STAFF REPORT

TO: Lake Elmo City Council
FROM: Nathan Fuerst, Consulting Planner
Jenni Faulkner, Consulting Planner
AGENDA ITEM: Wildflower Twinhomes, Preliminary Plat/Planned Unit Development

To:	Sophia Jensen, City Planner	Re:	Wildflower Twinhomes PUD
Cc:	Jenni Faulkner, Planning Consultant		Preliminary Plat/Plan Review
	Marty Powers, Public Works Director		
	Dustin Kalis, Fire Chief		
	Chad Isakson, PE, Assistant City Engineer		
From:	Jack Griffin, PE, City Engineer

TO: Sophia Jensen
FROM: Sarah Evenson, PLA
DATE: 3/10/2023
RE: City of Lake Elmo Revised PUD Application Review-
Landucci 39th St Twinhomes

PRELIMINARY PLAT

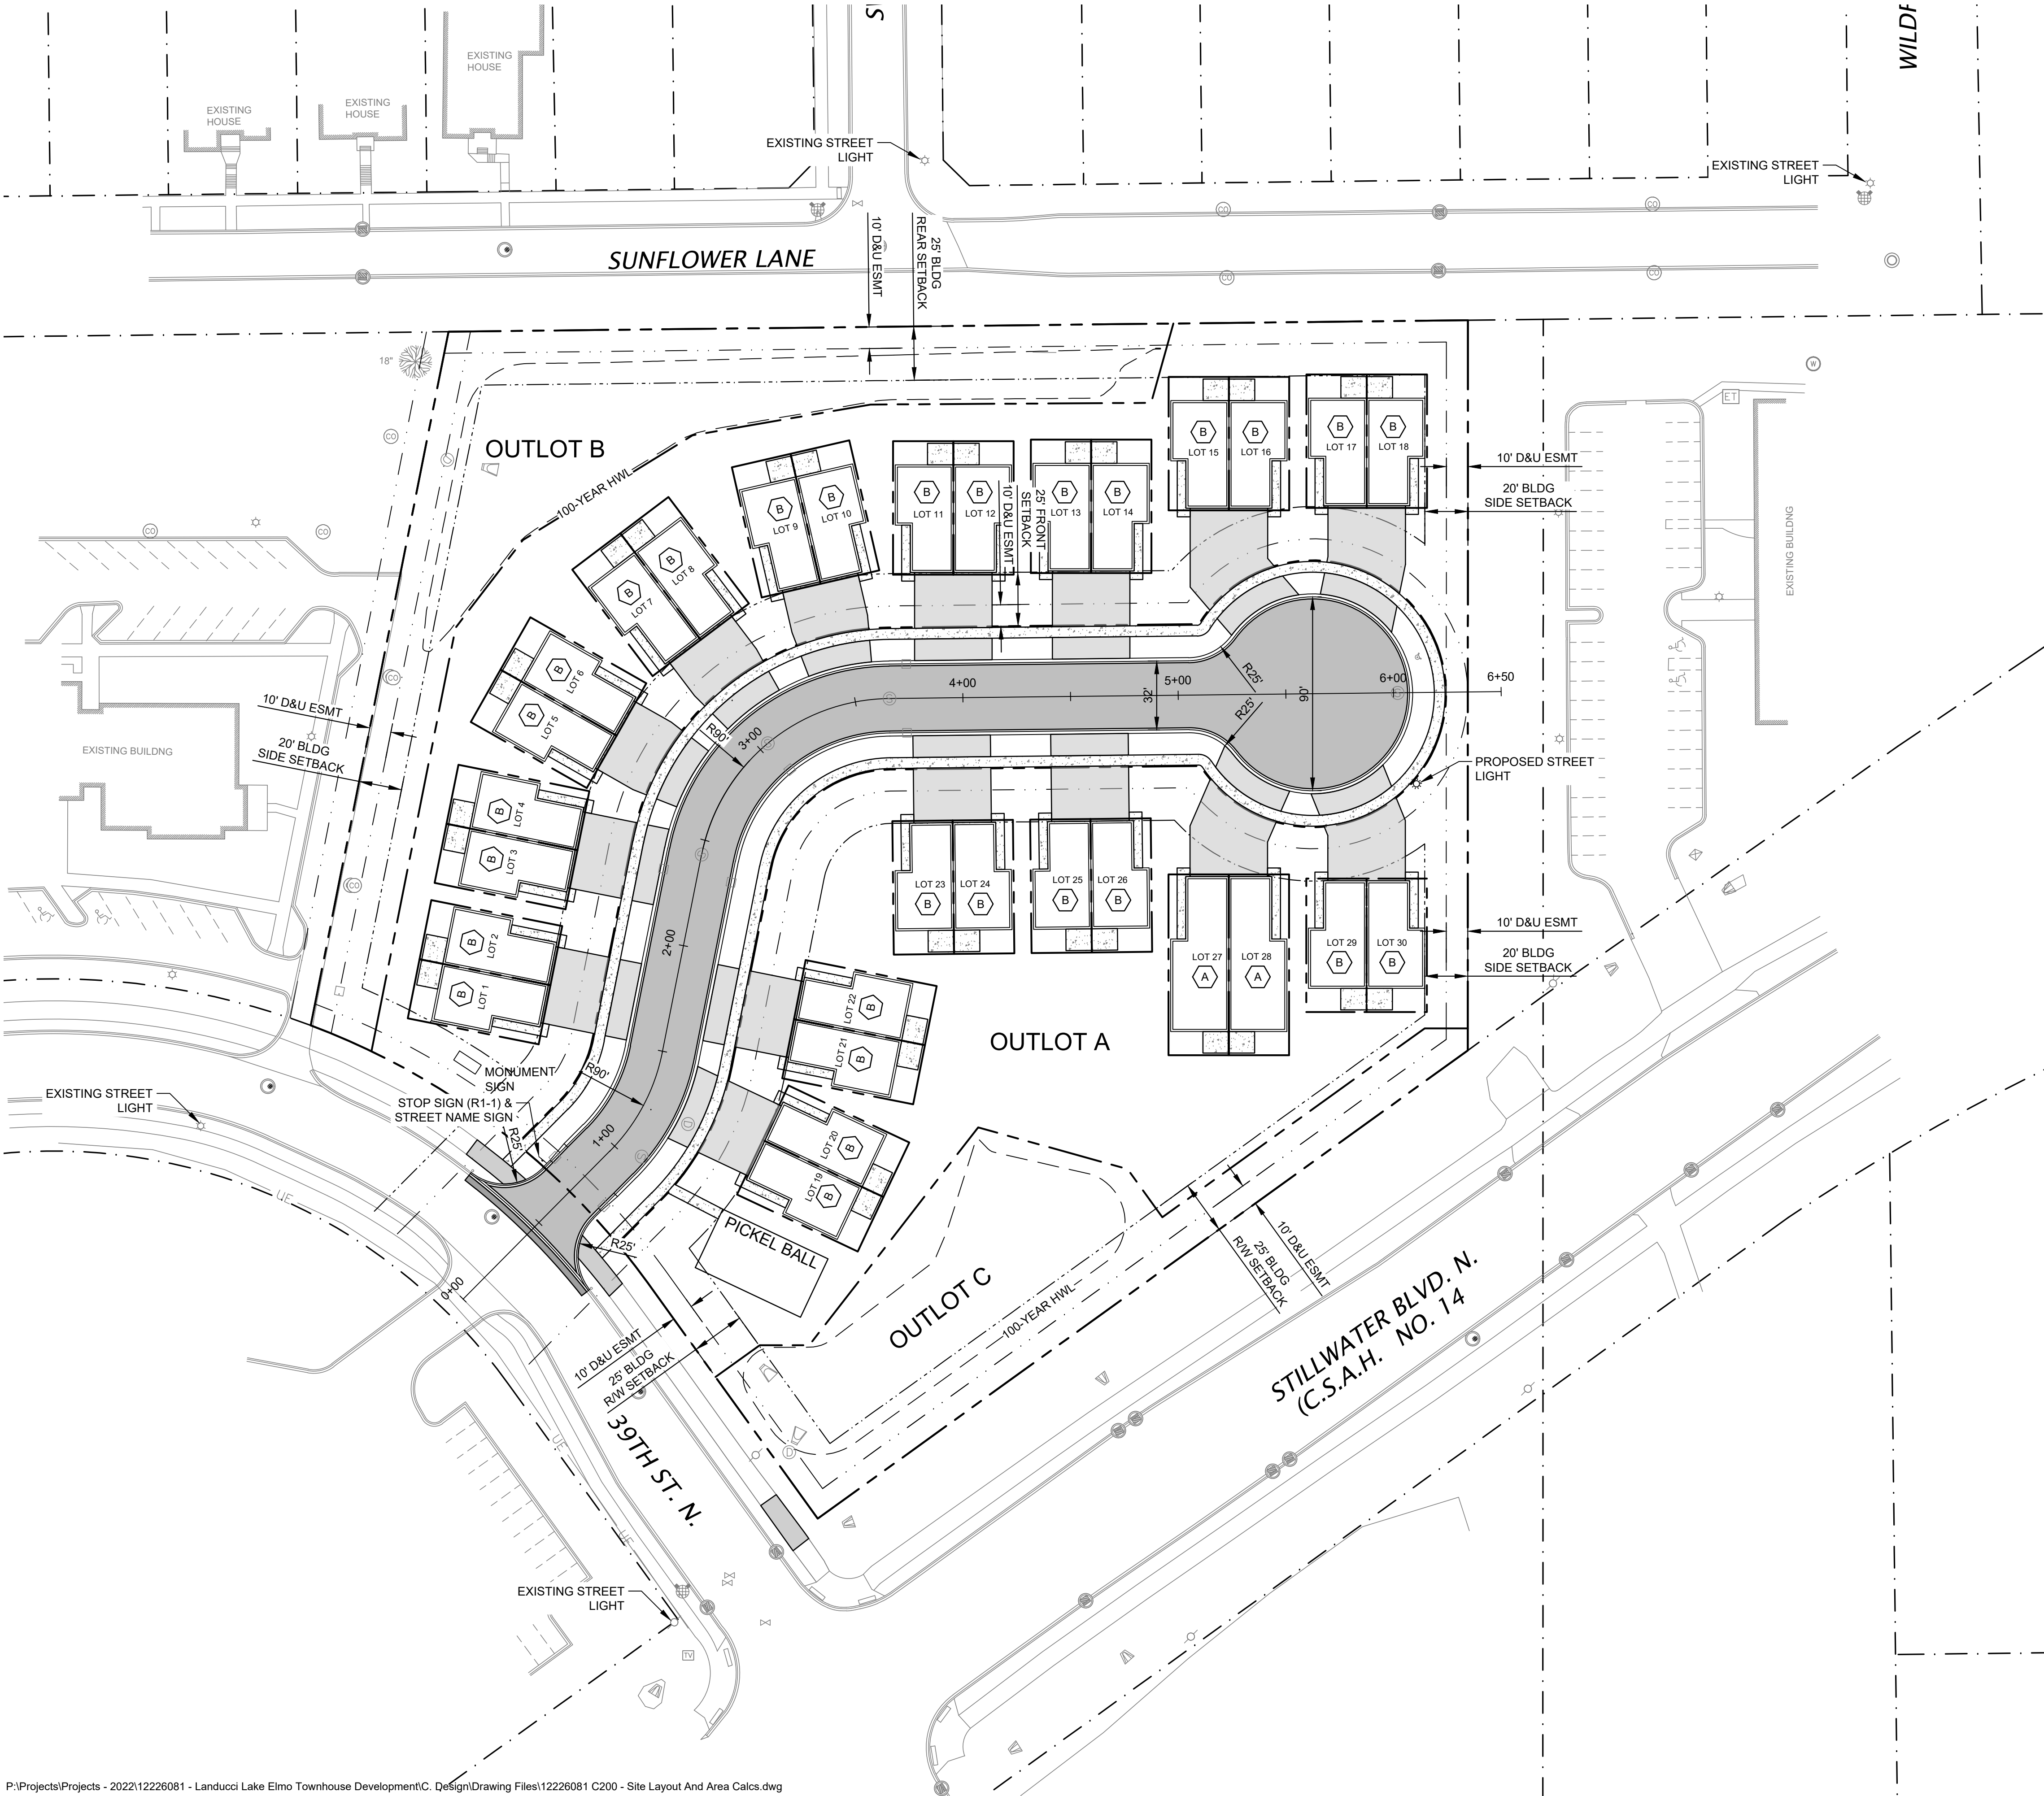
1. The Preliminary Plat and plans must be revised to show Outlot ownership and dedication. Outlot B and C should be shown as city owned for stormwater management basins. No drainage and utility easements should be shown over Outlots B and C. Outlot A should be shown as HOA owned.
2. Preliminary Plat approval must be contingent upon revisions to the Preliminary Plat as may be found necessary to dedicate additional right-of-way to accommodate any future County/City intersection improvements at Stillwater Boulevard and 39th Street.
3. Preliminary Plat approval must be contingent upon revisions to the Preliminary Plat as may be necessary to revise Outlot B and Outlot C to address to incorporate the 100-year HWL, 10-foot maintenance bench and all maintenance access roads; and to revise all building elevations as necessary to meet city and VBWD flood protection requirements.

4. The Preliminary Plat and Plans must be revised to show the building setbacks for Lots 1-15 to be 25 feet from the Outlot B property lines. Revisions to Lot 15 footprint will be required.

5. The Preliminary Plat and Plans must be revised to show all required Lot easements.
6. Phasing Plan. A condition of Preliminary and Final Plat approval must include the requirement to completion all utilities, stormwater management, street and sidewalk improvements including curb and gutter and the first lift of asphalt, sidewalks, and any off-site public improvements (if required) prior to issuance of any building permits. The development sequencing will be especially important for this very tight construction site and dead-end cul-de-sac.

Sheet:
L201

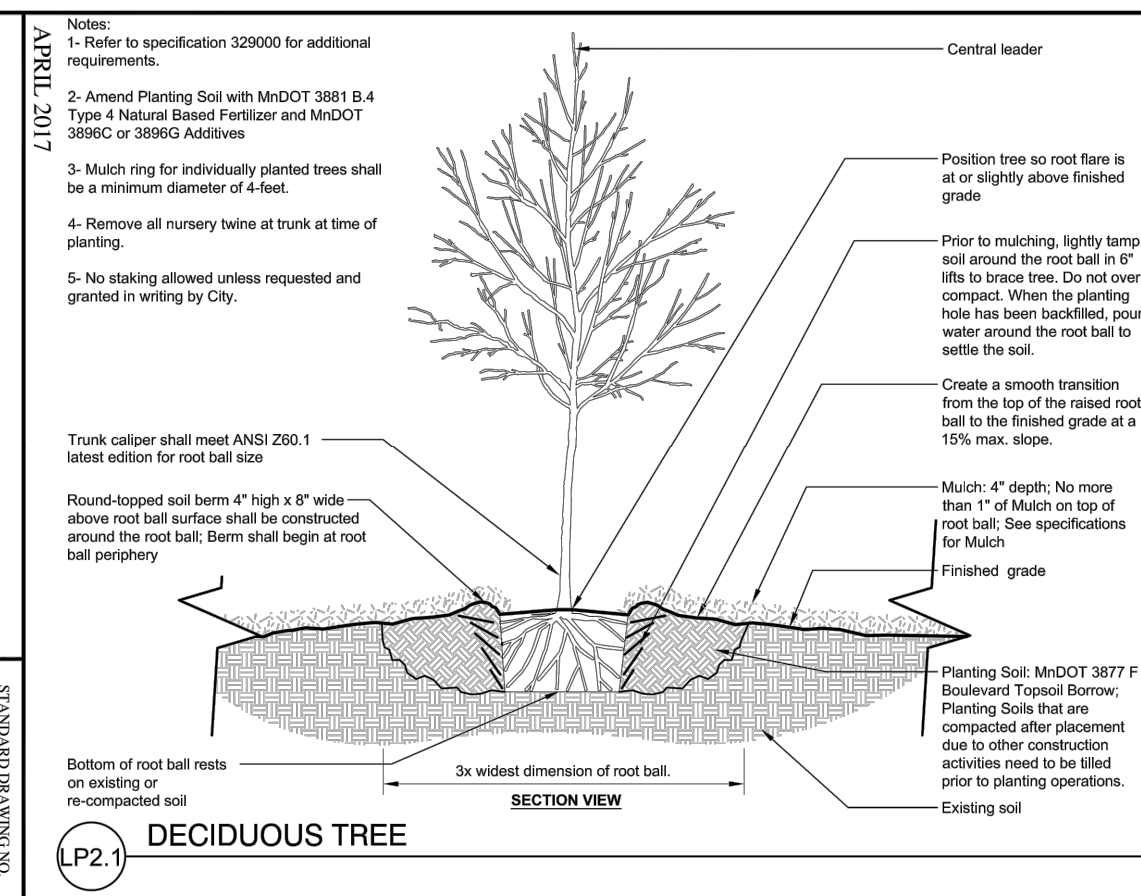
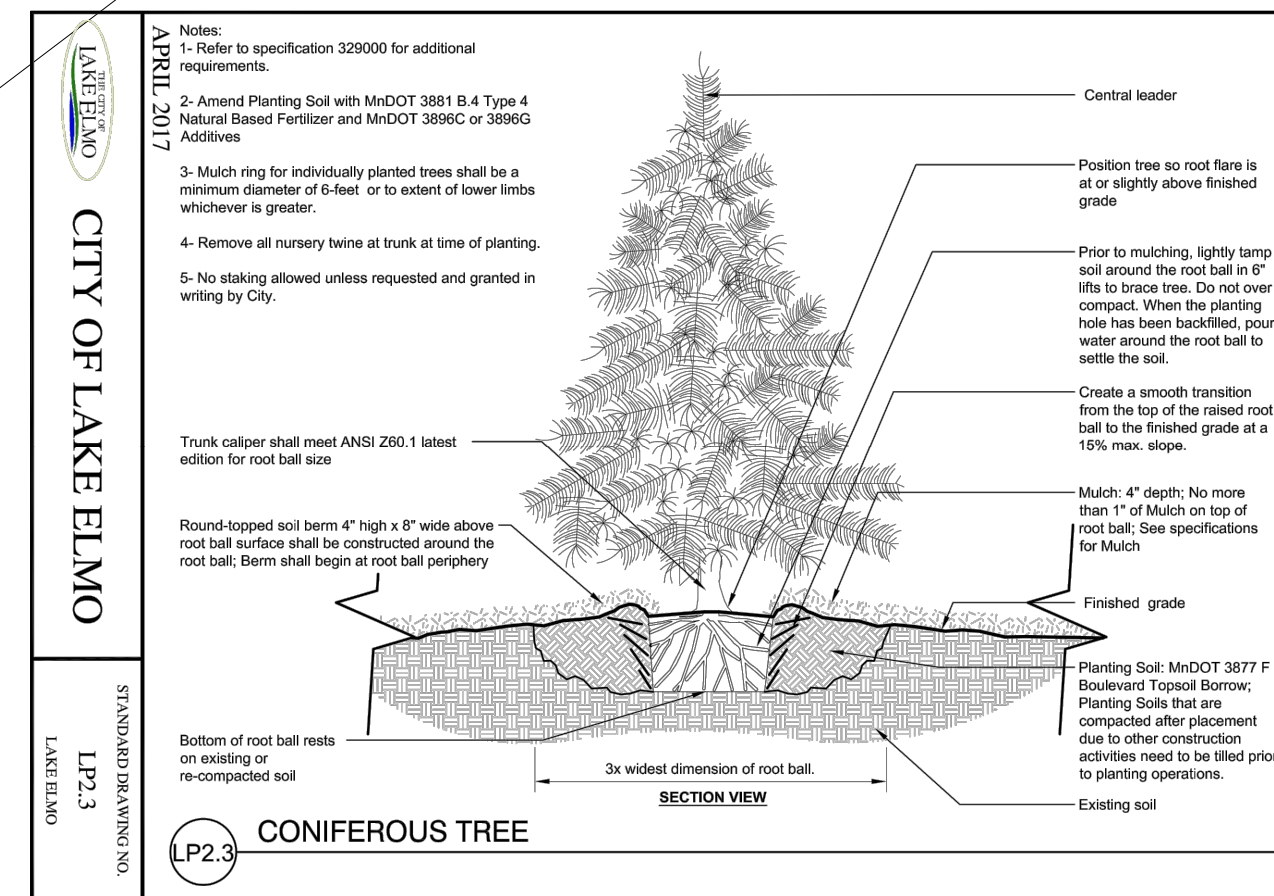
- The landscape plan will require the following adjustments in order to meet code:
 - Details and cross sections of all required screening need to be added to the landscape plans and must show that the proposed screening will be:
 - At least 6' in height and be 90% opaque year-round
 - A masonry wall or fence in combination with landscape material
 - 1 tree per 40 linear feet of property line
 - The landscape plan meets required number of trees:

- The tree composition requirements have not been met.
 - No more than 15% of proposed trees should be ornamental. Currently 20% of the trees are ornamental. Either replace these with other deciduous trees, or add additional coniferous/deciduous trees in order to bump the percentage of ornamental trees below 15%.

- Notes from the prior sheet set that were not included in this revised set still apply:
 - I am still concerned about the distance between the proposed pickleball court and adjacent homes. This is a better location than the last, but is still 15' from a residence. The noise will likely be disruptive. Surrounding court margins also appear short of the ideal 8-10'.
 - Are the rectangular shapes near the pickleball court intended to be bench seating? If so, maintain access via a navigable surface such as concrete, compacted crushed limestone, or decomposed granite.
 - Label what the rectangular shapes in the entry sign planting bed are, either in the legend or via note.
